**RE: Lot 5 Block 9 SAD 228 Volcano Cliffs
6428 Picardia NW
Grading and Drainage Plan
Engineers Stamp Date 8/8/18 (D10D003Q5)
Pad Certification Dated 10/8/18**

DRAINAGE AND TRANSPORTATION INFORMATION SHEET (REV 6/2018)

ENGINEER'S SEAL  8/8/18 DAVID SOULE P.E. #14522	LOT 5, BK 9 UN 22 VOLCANO CLIFFS 6428 PICARDIA PLACE GRADING AND DRAINAGE PLAN  1606 CENTRAL AVENUE SE SUITE 201 ALBUQUERQUE, NM 87106 (505) 872-0289	DRAWN BY DEM
		DATE 8-7-18 SHEET # C1 JOB #

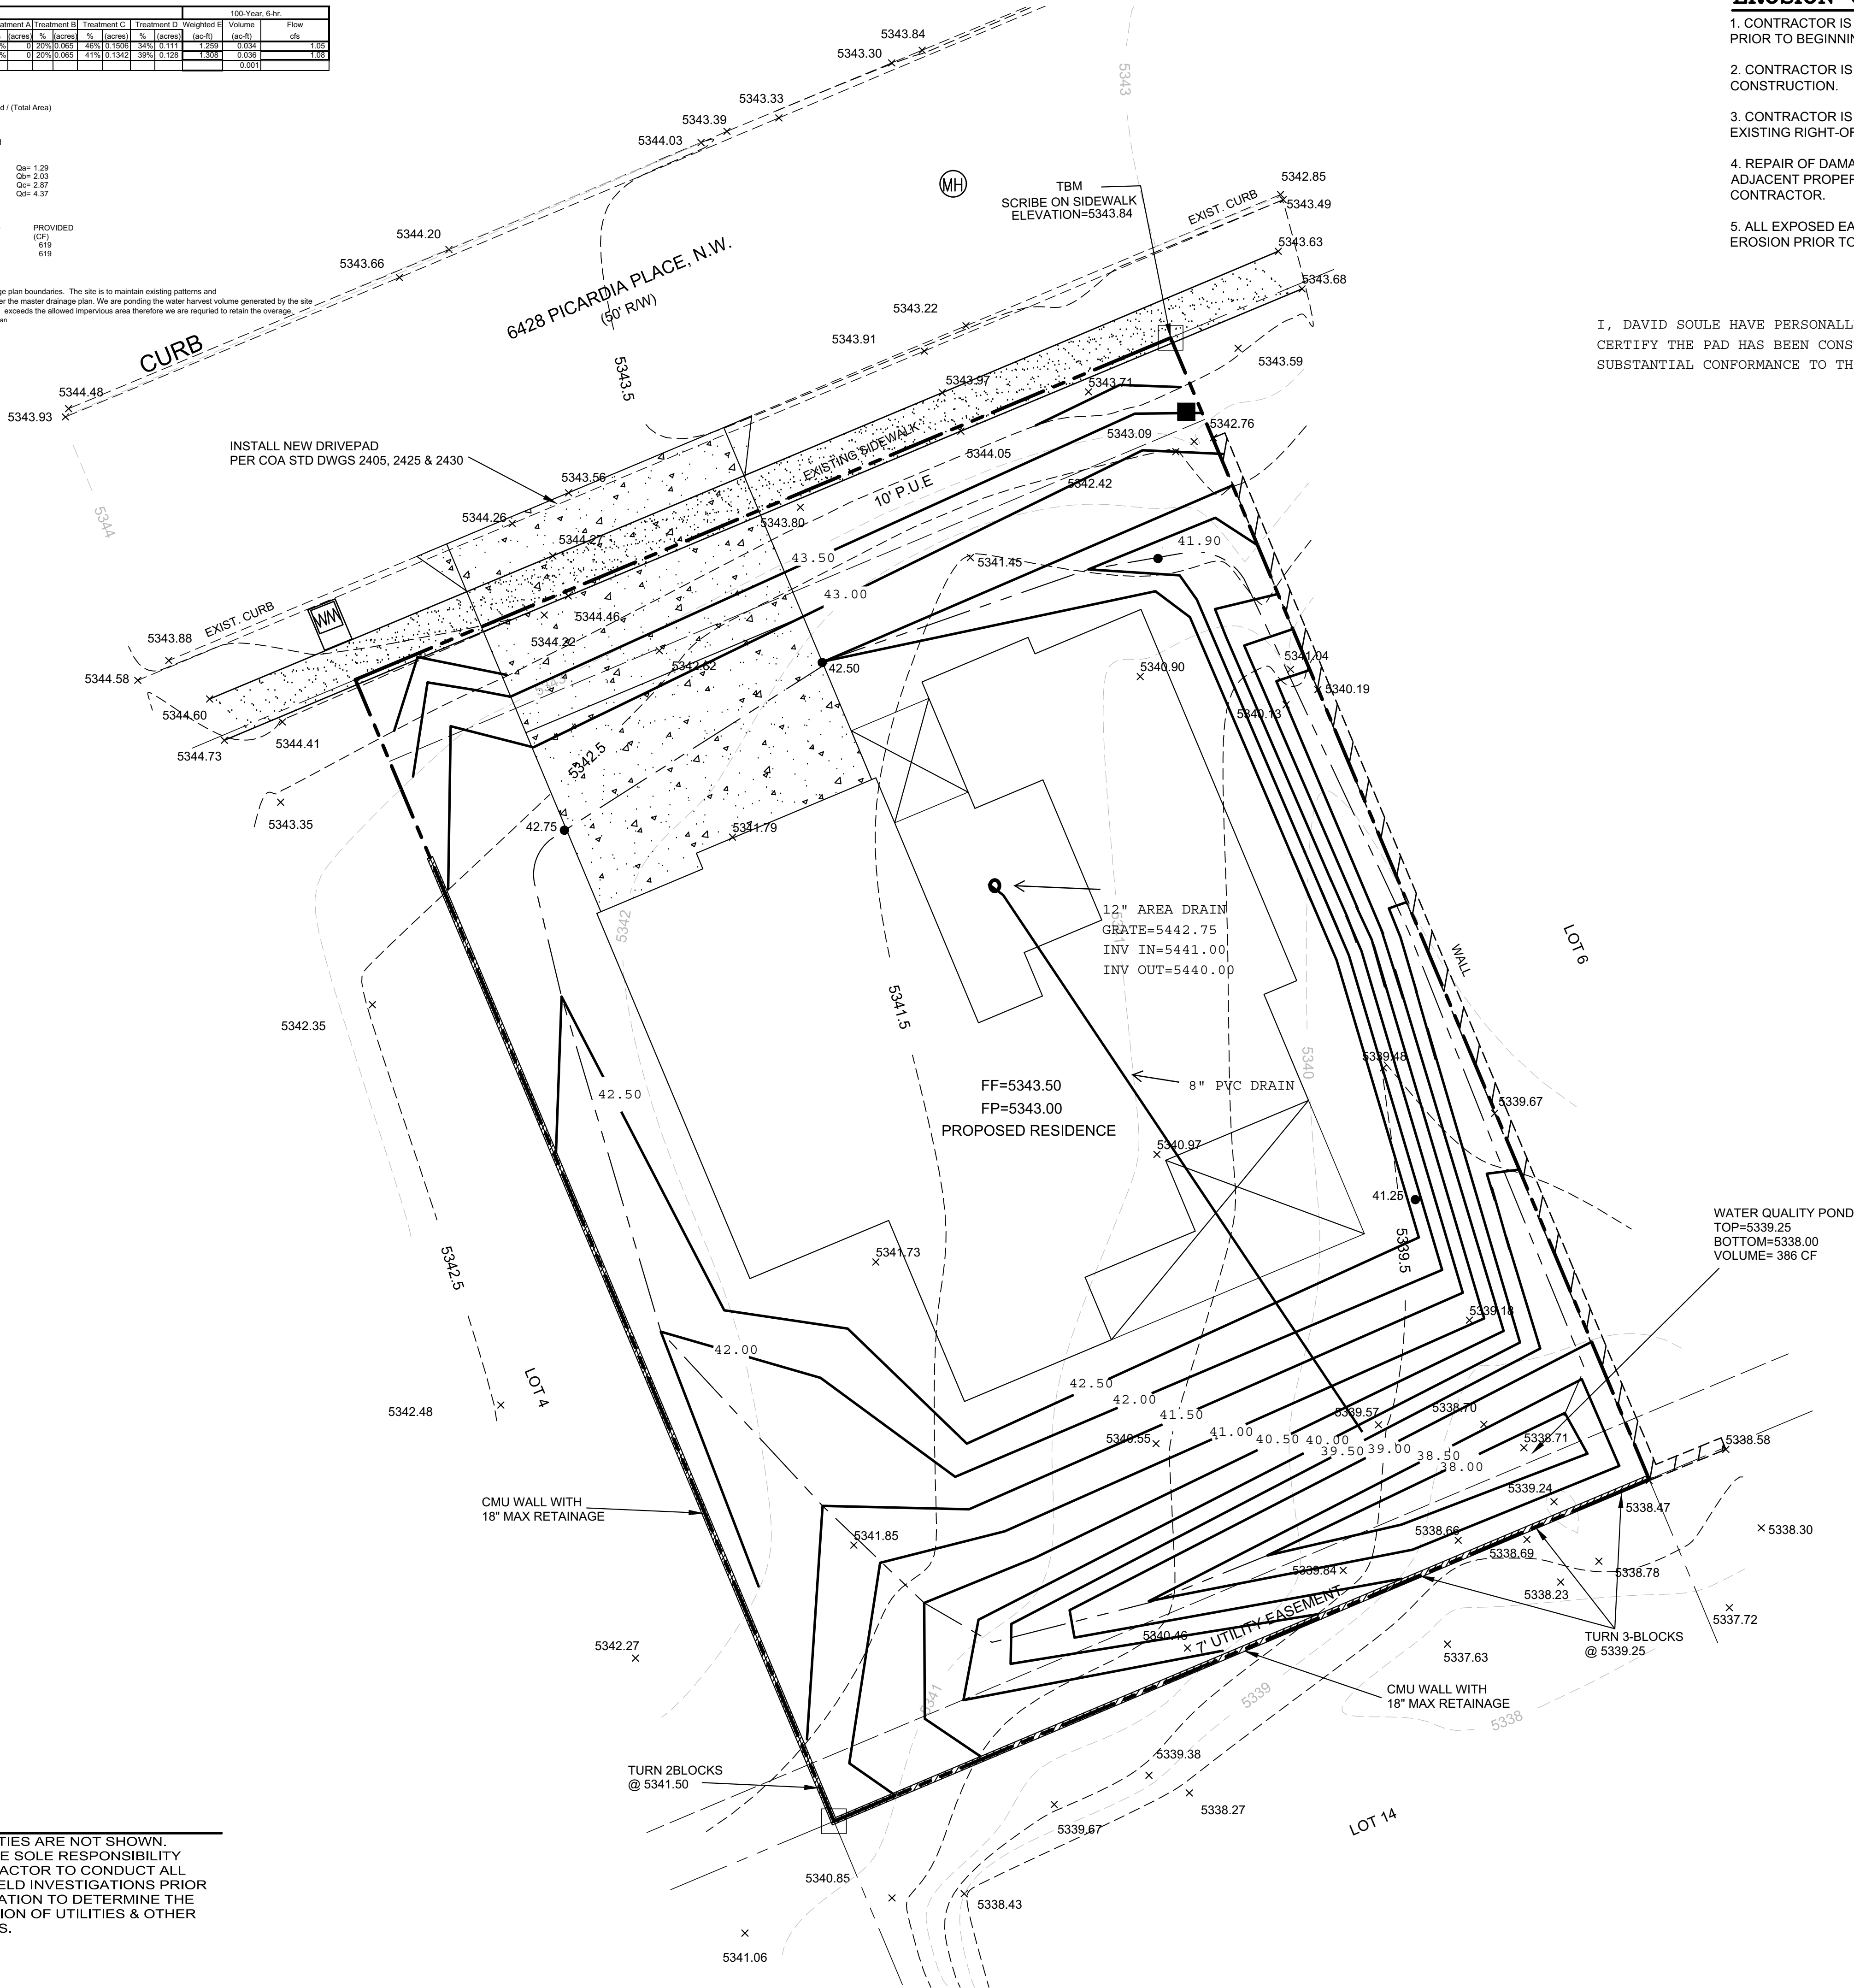
- Remove the dirt from Picardia St, the sidewalk and the mow strip.
